SUNDRY NOTICES AND REPORTS ON WELLS (DO NOT USE THIS FORM FOR PROPOSALS TO DRILL OR TO DEEPEN OR PLUG BACK TO A DIFFERENT RESERVOIR USE "APPLICATION FOR PERMIT" (FORM C-101) FOR SUCH PROPOSALS)		WELL API NO. 30-005-63715 ✓

2. Name of Operator Yates Petroleum Corporation ✓		6. State Oil & Gas Lease No. VA-2042
3. Address of Operator 105 South Fourth Street, Artesia, NM 88210		7. Lease Name or Unit Agreement Name Dice BLT State Com ✓

Yates Petroleum Corporation plans to plug and abandon this well as follows:

CONDITIONS OF APPROVAL FOR PLUGGING & ABANDONMENT

BEFORE

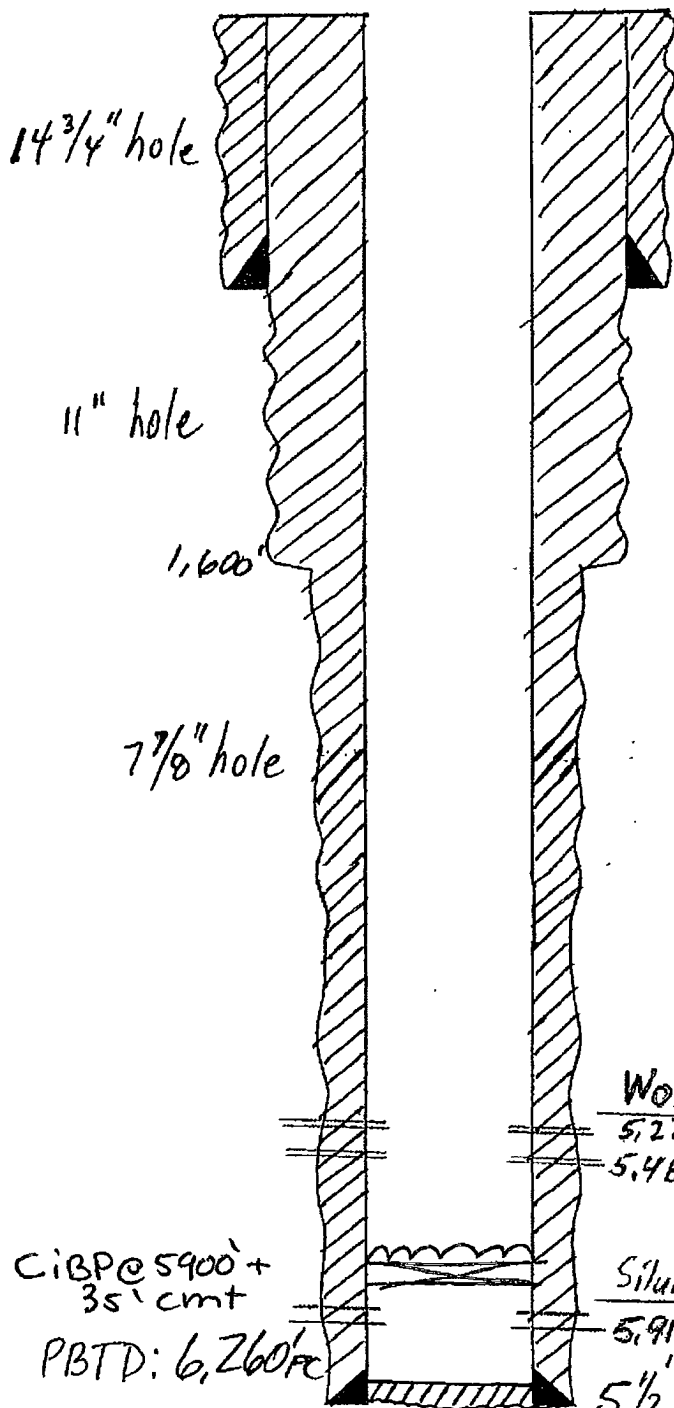
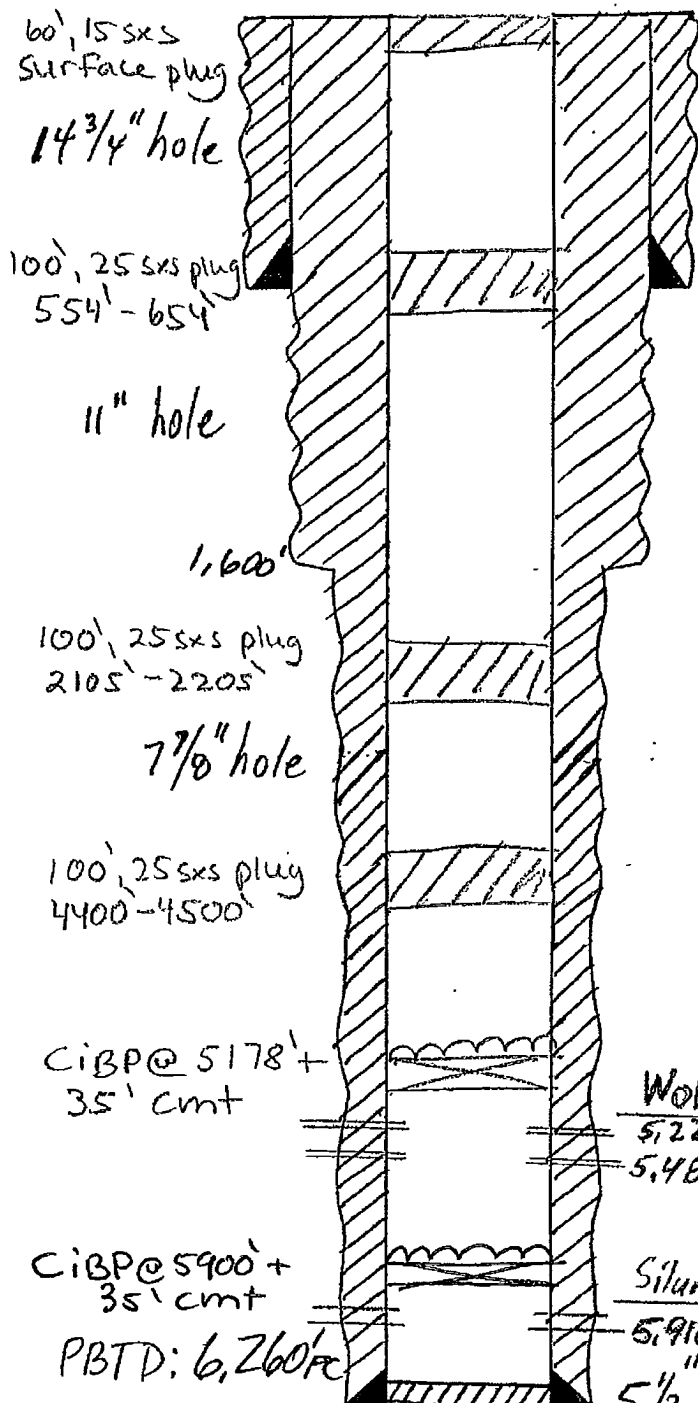
1. MIRU WSU. Rig up all safety equipment as needed. No casing recovery will be attempted.
2. Set a CIBP at 5178' with 35' cement on top. This will place a plug over Wolfcamp perforations.
3. Spot a 25 sx Class "C" cement plug from 4400'-4500'. This will place 100' cement plug across top of the Abo.
4. Spot a 25 sx Class "C" cement plug from 2105'-2205'. This will place 100' cement plug across top of Glorieta.
5. Spot a 25 sx Class "C" cement plug from 554'-654'. This will place 100' cement plug across surface casing shoe. WOC and tag plug.
6. Spot a 15 sx Class "C" cement plug from 60' up to surface.
7. Remove all surface equipment, weld dry hole marker and clean location as per regulations.

1. Produced water will not be used during any part of the plugging & abandonment operation.
2. Notify NMOCD Dist. 2 office at least 24 hrs before beginning work.

6. Every attempt must be made to clean the well bore out to below the perfs, before any plugs can be set, by whatever means possible.
